TOPOGRAPHIC SURVEY  
LOT 2A AND 2 B  
BROADWAY INDUSTRIAL CENTER  
UNIT 2  
BERNALILLO COUNTY, NEW MEXICO  
JUNE 2013

DRAINAGE CERTIFICATION LOT 2-B

DRAINAGE CERTIFICATION LOT 2-A

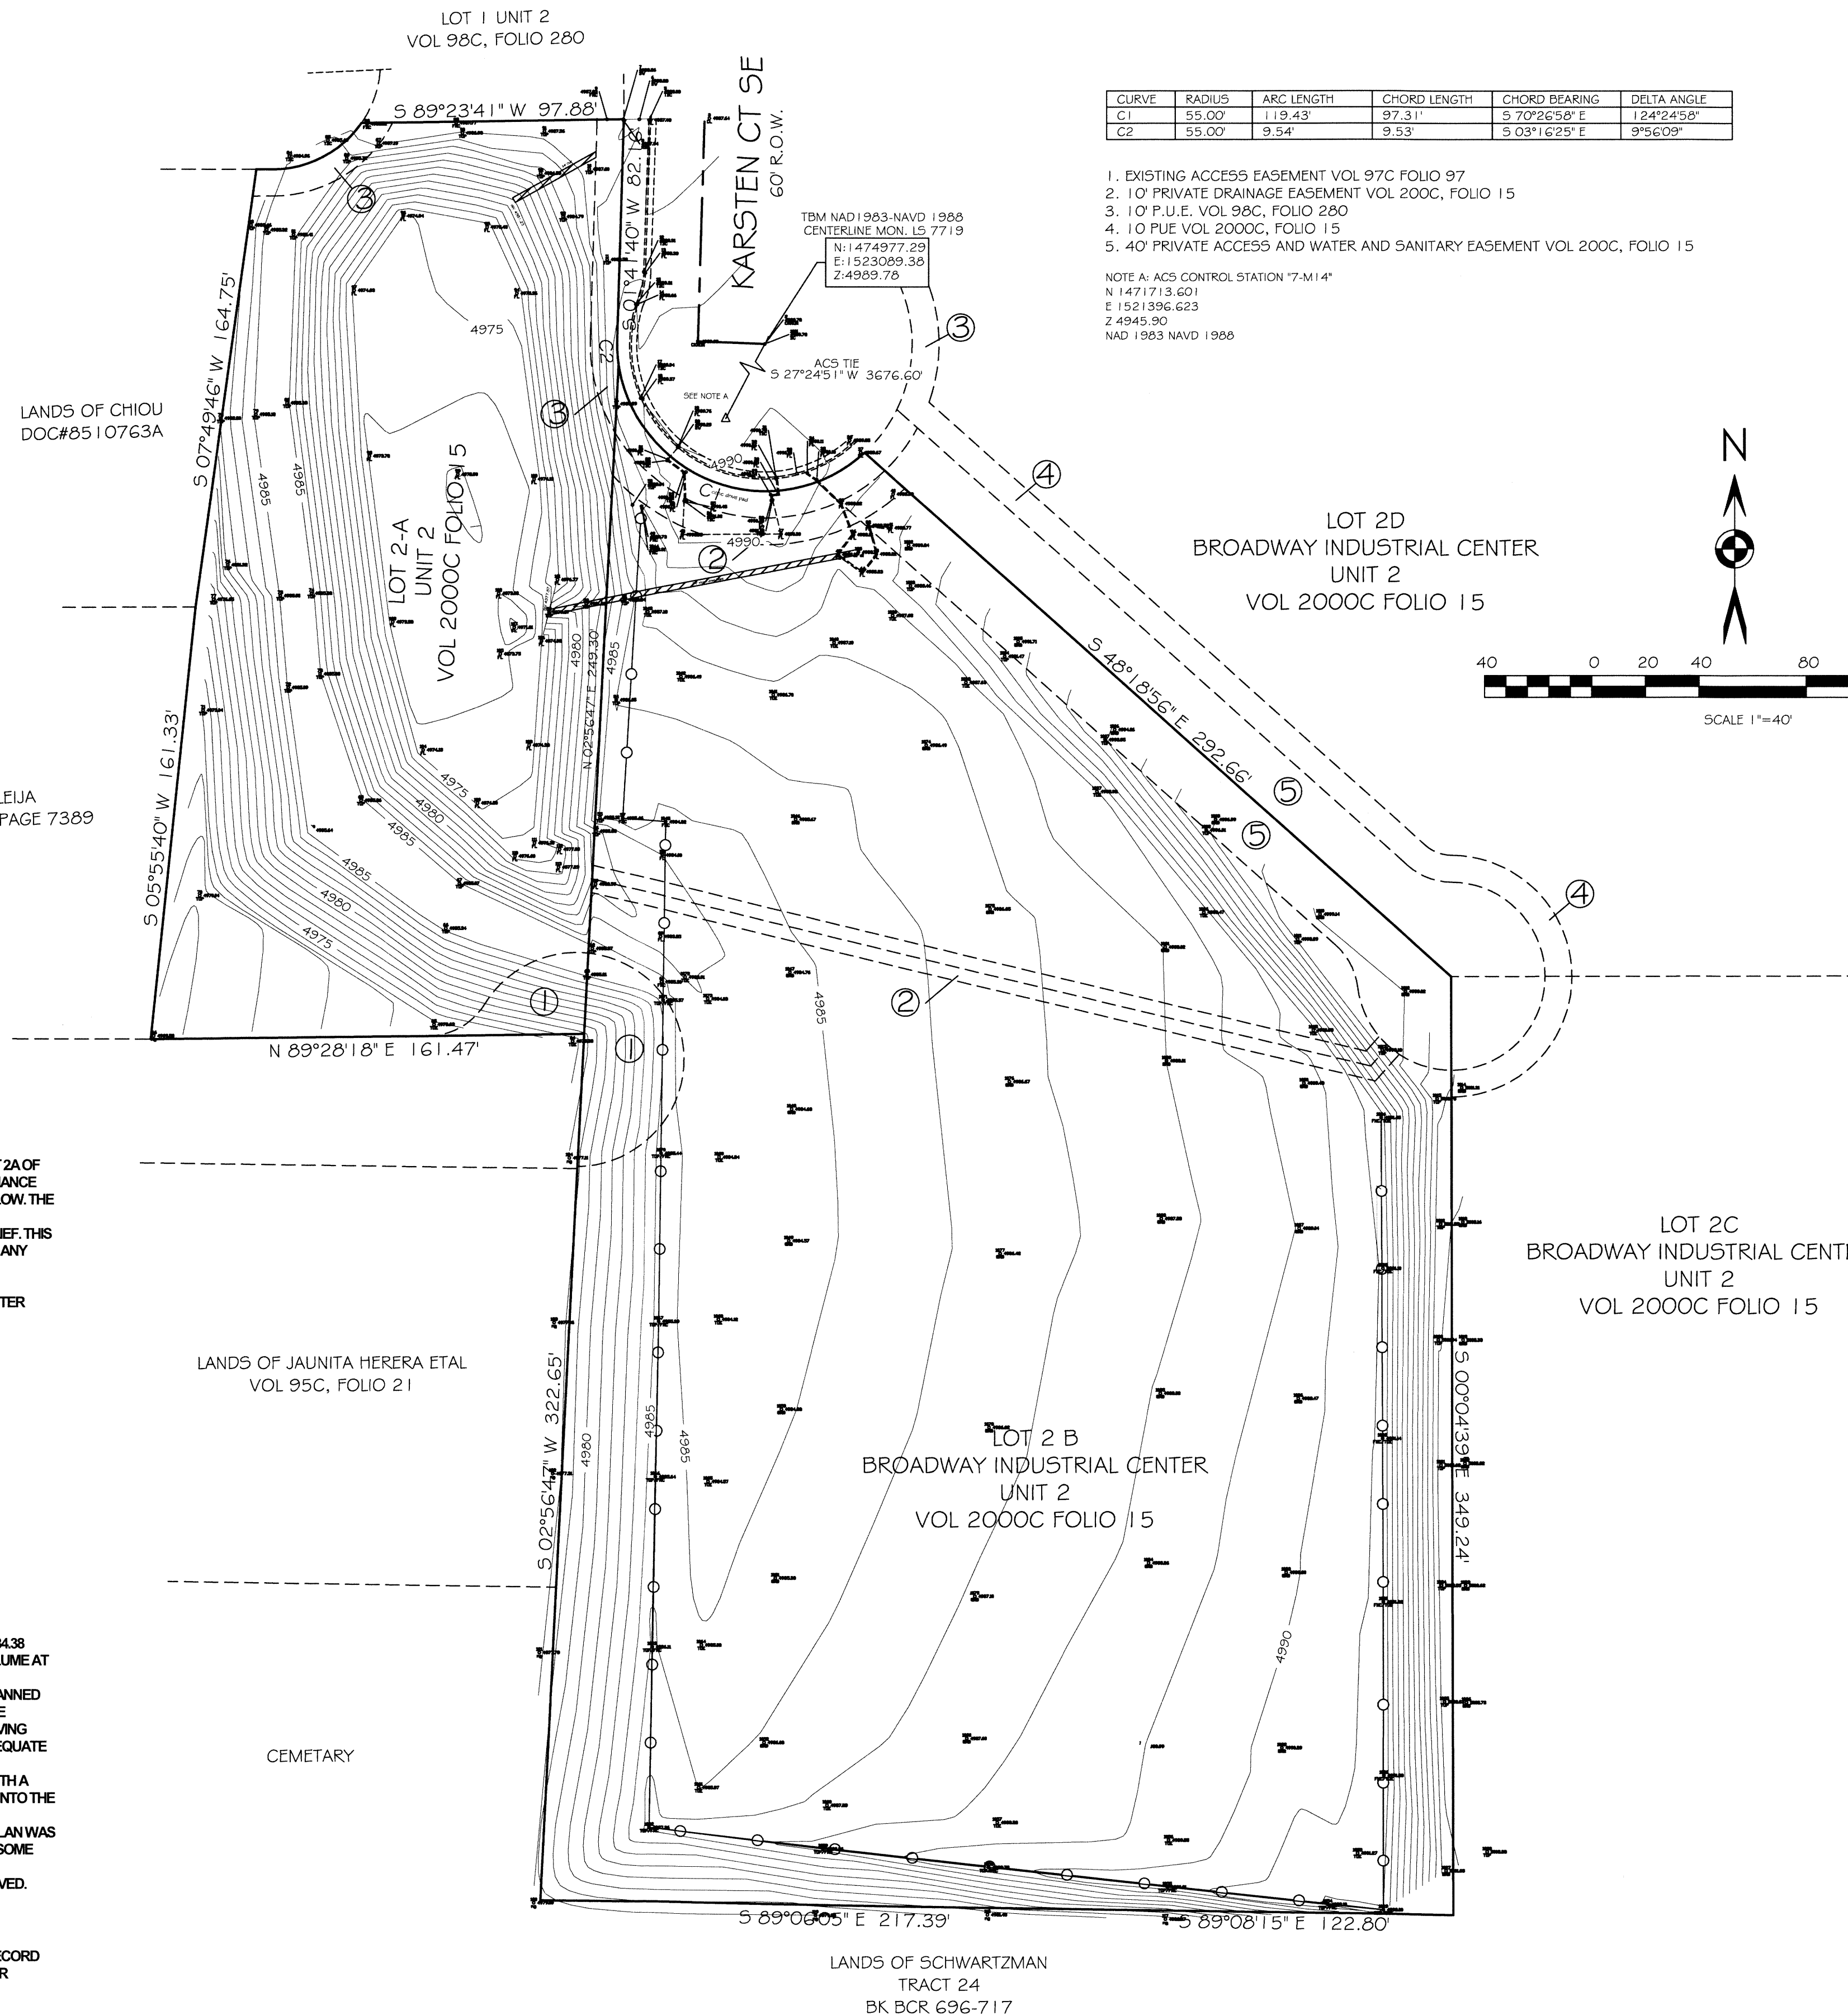
1. USING THE TOPOGRAPHIC SURVEY, THE REQUIRED VOLUME OF 4.225 AC FT FILLS THE POND TO ELEVATION 4884.38 WHICH IS ABOUT 0.8' BELOW THE TOP OF DAM AND THE EMERGENCY OVERFLOW SPILLWAY. THE ASBUILT VOLUME AT ELEVATION 4885.0 IS 4.81 AC FT. THE POND STORAGE VOLUME IS ADEQUATE.

2. AFTER ADDING 2.7' TO THE 9/14/99 PLANNED ELEVATIONS TO CONVERT FROM NGVD 1929 TO NAVD 1988 THE PLANNED TOP OF DAM ELEVATION 4885.7 IS HIGHER THAN THE LOWEST SURVEYED TOP OF DAM ELEVATION, 4885.1. MORE IMPORTANTLY, THE LOWEST SURVEYED ELEVATION IN THE EMERGENCY OVERFLOW SPILLWAY IS 4884.96 LEAVING ONLY 0.14' BETWEEN THE SPILLWAY ELEVATION AND THE TOP OF DAM ELEVATION, THUS INDICATING AN INADEQUATE EMERGENCY OVERFLOW SPILLWAY. A NEW SPILLWAY PLAN NEEDS TO BE DEVELOPED AND CONSTRUCTED.

3. OTHER SUBSEQUENT DEVELOPMENTS, SPECIFICALLY BUILDING PERMITS FOR LOT 2C AND LOT 2D TOGETHER WITH A NEW STORM PIPE CONNECTED TO A PUBLIC INLET IN KARSTEN CT, CONVEY THE MAJORITY OF THE DRAINAGE INTO THE POND IN PIPES CONSTRUCTED BY THOSE SEPARATE DEVELOPMENTS. SCOUR HOLES AT BOTH OF THE PIPES THREATEN TO UNDERMINE THE ENDS OF THE PIPES. THE CONCRETE RUNDOWN SHOWN ON THE APPROVED PLAN WAS INSTEAD CONSTRUCTED AS A RIP-RAP RUNDOWN AND IS ALSO DAMAGED BY SCOUR. DUMPED RIP-RAP WITH SOME HAND PLACEMENT MAY BE A GOOD REMEDY TO ALL OF THESE SCOUR PROBLEMS.

4. TREES ARE GROWING IN THE DAM. THEY HAVE NOT CAUSED ANY DAMAGE YET BUT THEY SHOULD BE REMOVED.
